**CHANGE**

**U.S. DEPARTMENT OF TRANSPORTATION  
FEDERAL AVIATION ADMINISTRATION**

8260.49A  
CHG 1

**SUBJ: Simultaneous Offset Instrument Approach (SOIA)**

Figure 1. Examples of SOIA Design with Staggered Thresholds

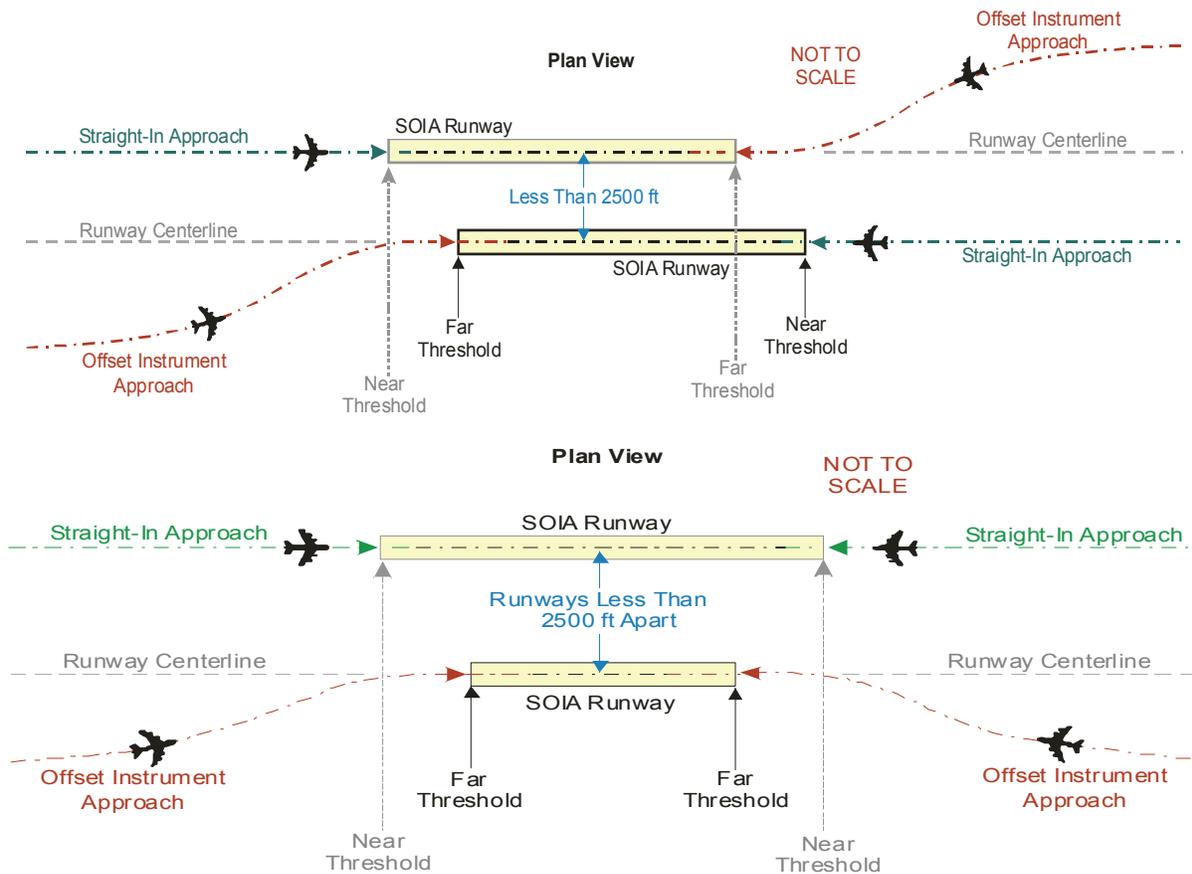
- (1) Clarified the method for design to staggered thresholds.
- (2) Added guidance for approaches that use RNAV (GPS) or RNAV (RNP) AR.

Where there is a stagger between the arrival thresholds on runways separated by less than 2,500 ft, construct the offset course approach to the runway with the far threshold as depicted in figure 1. The offset course approach glide slope angle must be equal to or greater than the straight-in approach glide slope angle.

**Figure 2. Missed Approach Evaluation**

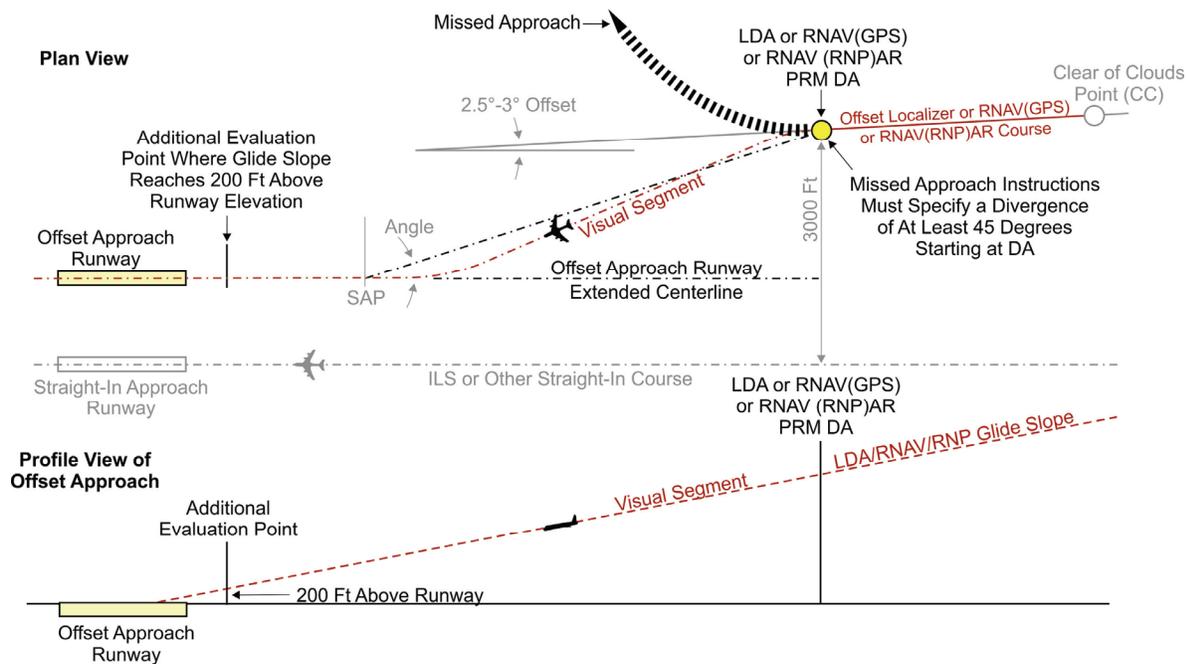
- (1) Changed the missed approach evaluation, based on user request, to also consider a go-around executed past the DA.
- (2) Incorporated AFS-400 Memorandum, dated 07/30/2008.

- 12.0.2** In addition to the evaluation beginning at the DA (see paragraph 10.2), evaluate an additional missed approach segment from a point on the offset course approach runway's extended centerline at a height of 200 ft above the runway threshold to determine the impact of obstacles on a go-around executed past the MAP (Offset Course Approach DA). For the additional missed approach segment, evaluate an ILS approach DA that is on runway centerline at 200 feet above the landing threshold point (LTP). Apply the current missed approach TERPS criteria for an ILS approach with a turning missed approach; use the same missed approach heading/course as is used for the published missed approach (the missed approach at the MAP). See figure 2.
